## Arklow Flood Relief Scheme

Response to Submissions relating to  
Planning & Environmental Matters  
(ABP ref 301368-21 & 310377-21)

D5246

Issue | 12 January 2022

Mountpleasant Business Centre, Ranelagh, Dublin D06 X7P9  
Tel: +353(0)1 208 1990

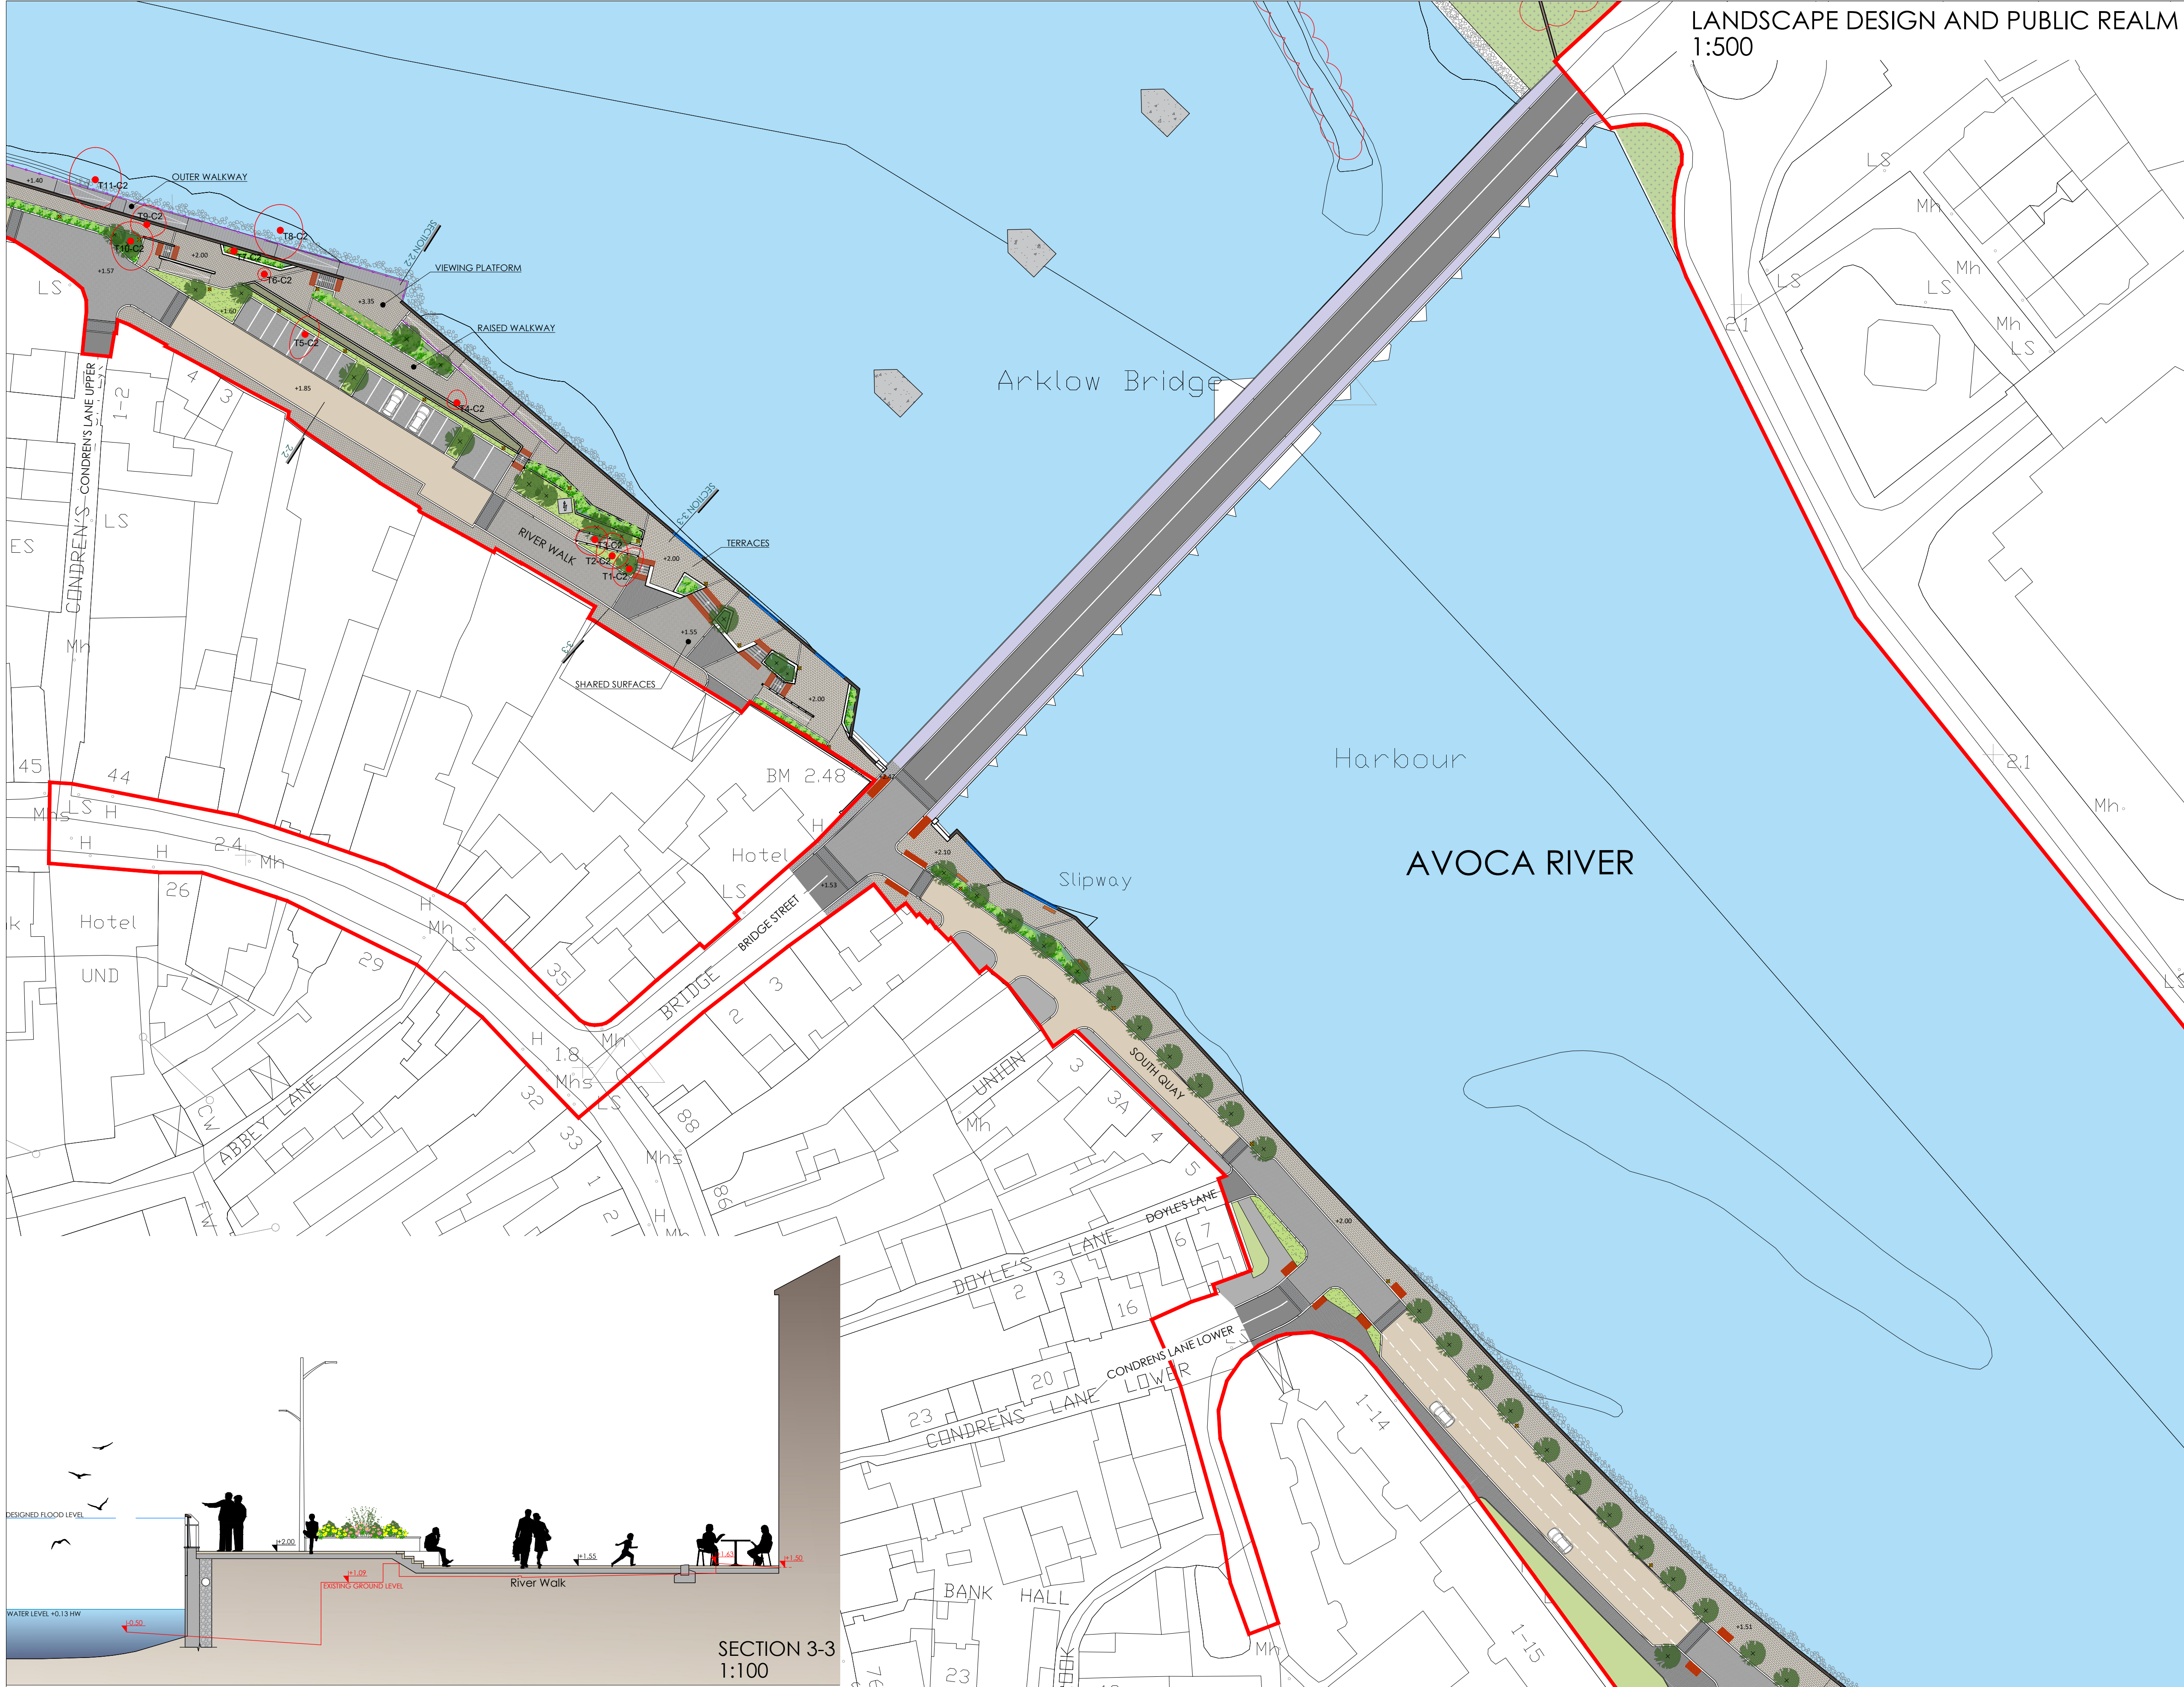
In response to the submissions/objections received by ABP, it is now proposed to include an additional 30.0m of glazing at the following locations listed below. Drawing Nos 1036-1042 and 1046 of Appendix 4.1 (*Scheme Drawings*) and Drawing Nos 301-302 of Appendix 4.2 (*Landscape Design and Public Realm Drawings*) of the EIAR have been revised to reflect these changes and are included in **Appendix A** of this report.

- Addition of two 6.0m long glass panels just downstream of Arklow Bridge on South Quay at approximately Ch 020 (12.0m total), as shown on revised Scheme Drawing No 1040 and revised Landscape Design and Public Realm Drawing No 301 in **Appendix A** of this report. This will open up views of the bridge downstream.
- Addition of three 6.0m long glass panels along South Quay at approximately Chainage 370 (18.0m total), as shown on revised Scheme Drawing No 1041 and revised Landscape Design and Public Realm Drawing No 302 in **Appendix A** of this report.
